MCDONALD'S RESTAURANT
10950 S. Parker Road
Parker, Colorado

DRAINAGE REPORT

Revised: October 10, 2025

MCDONALDS REMODEL AT PARKER CENTRAL AREA FILING NO. 5, BLOCK 1, LOT 2 CONSTRUCTION PLANS

DR-2

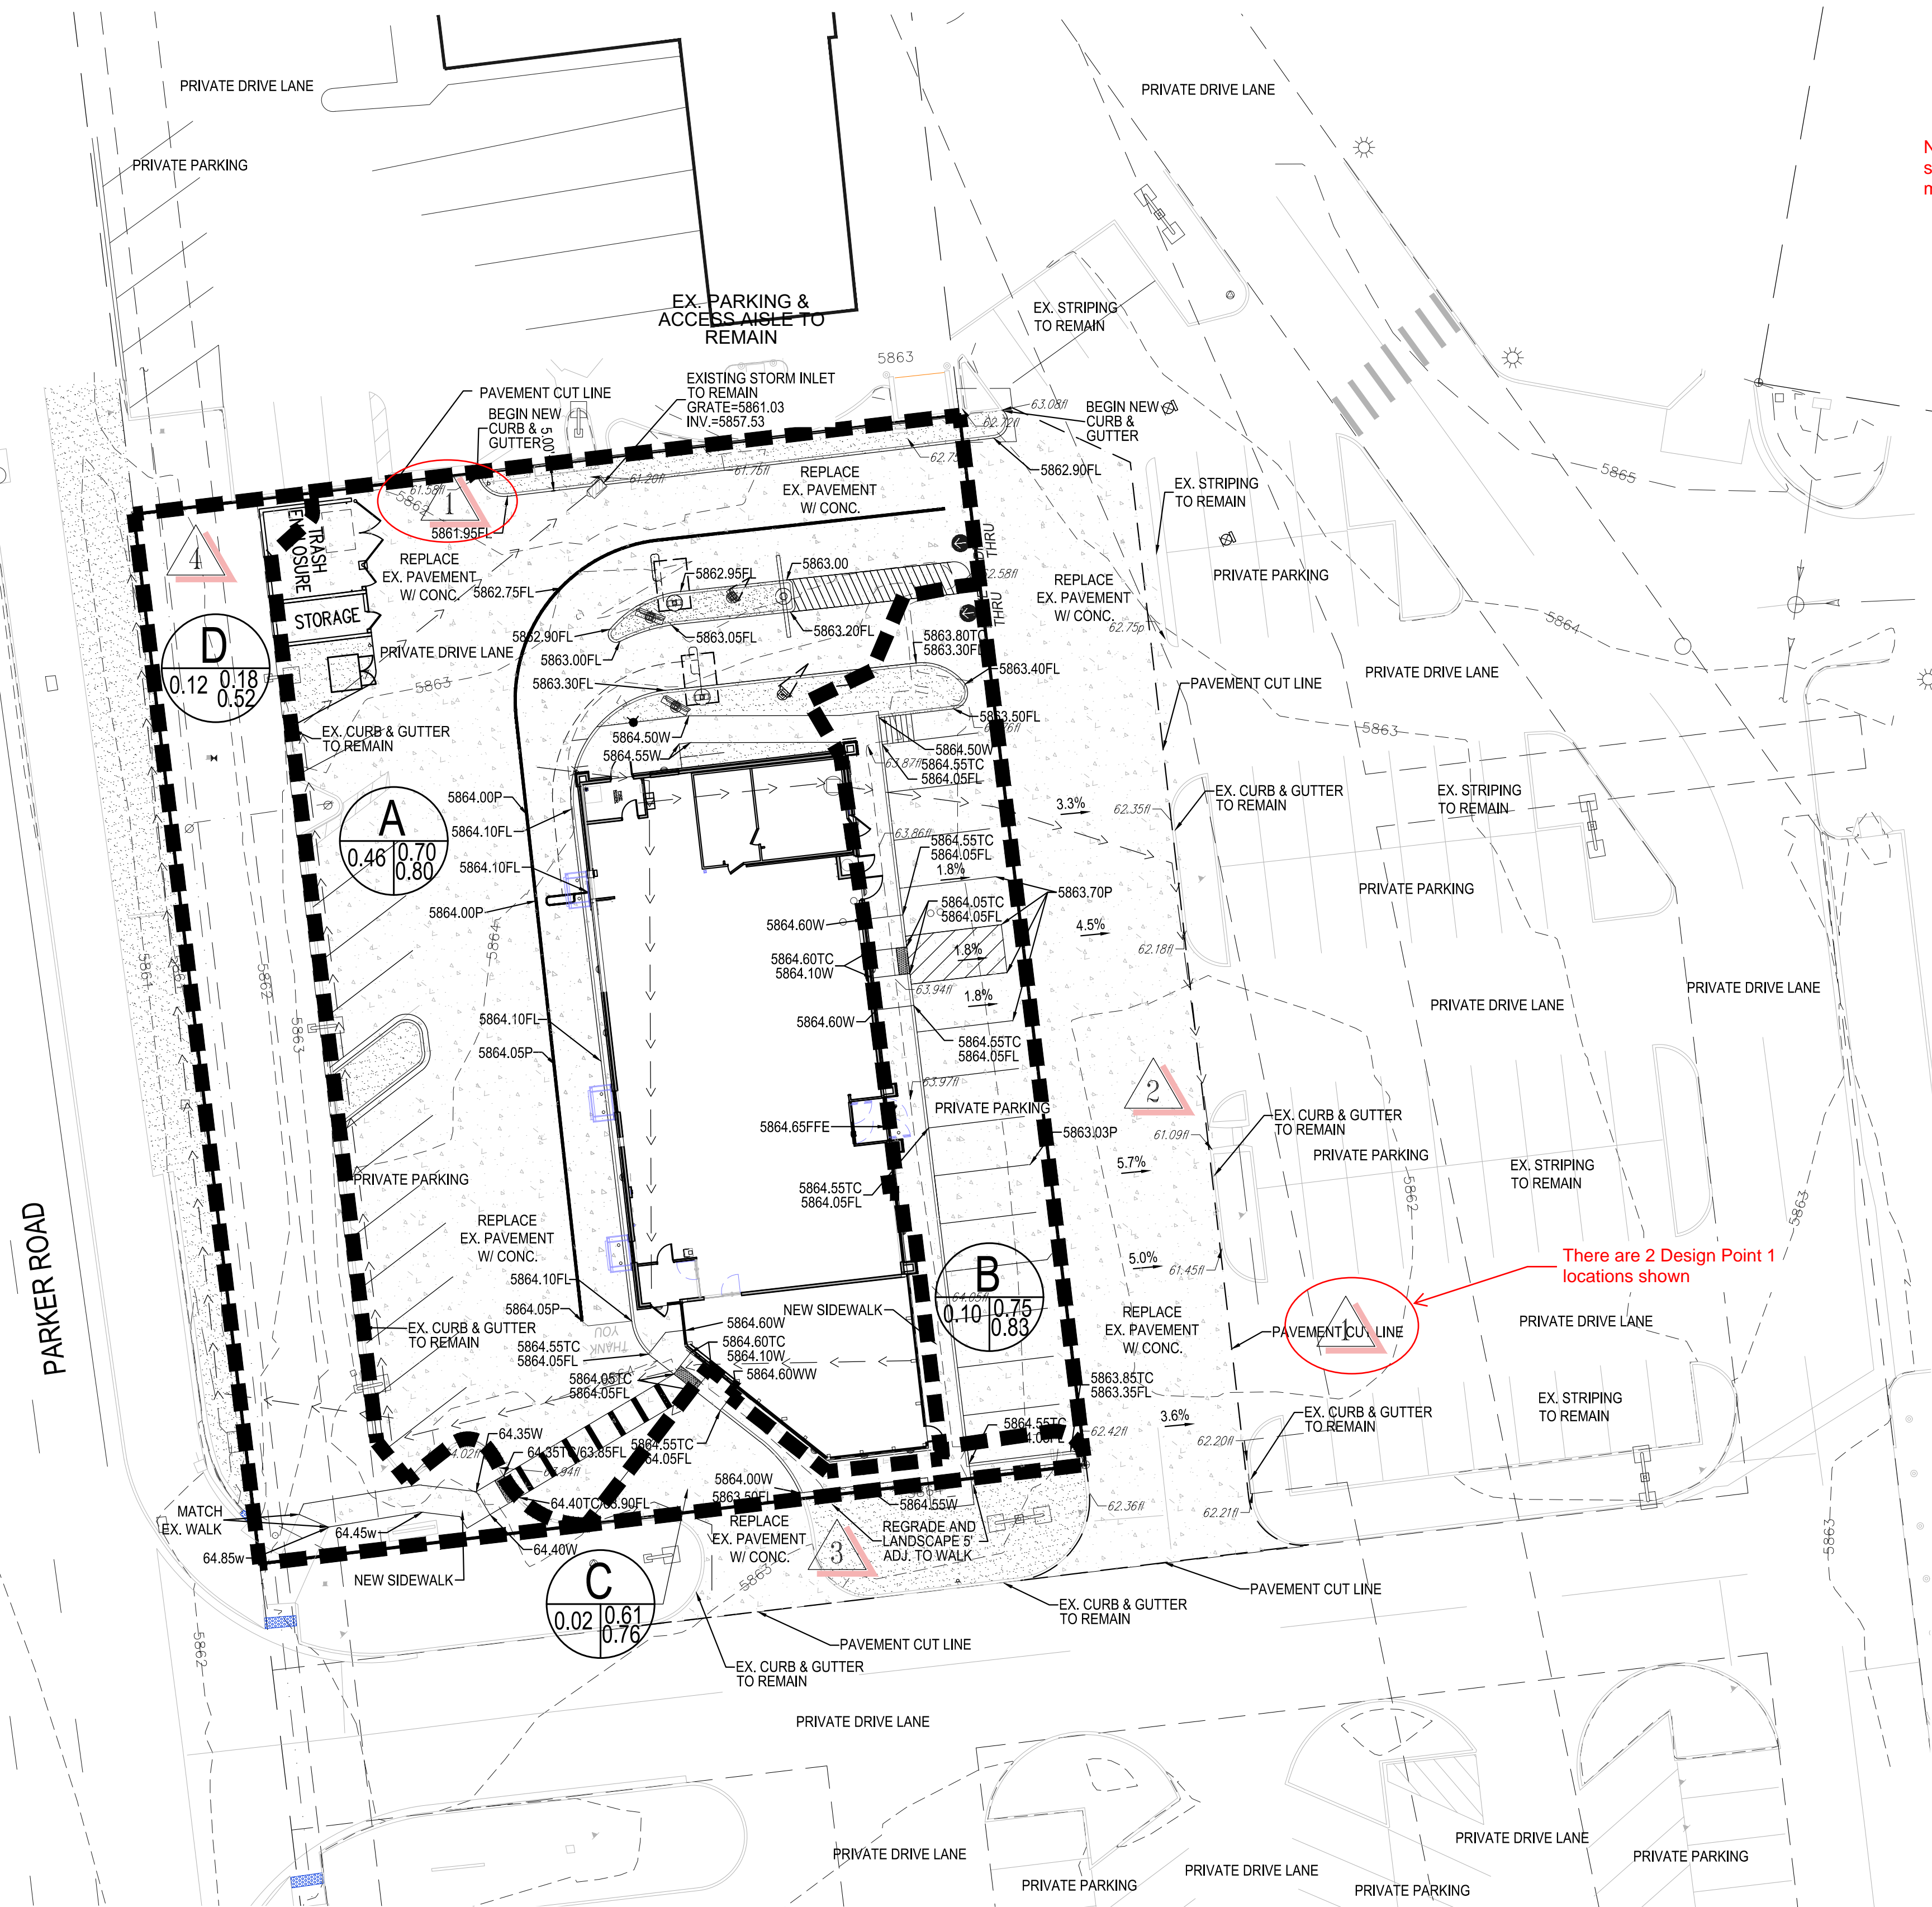
No Design Point 5 shown in the basin map
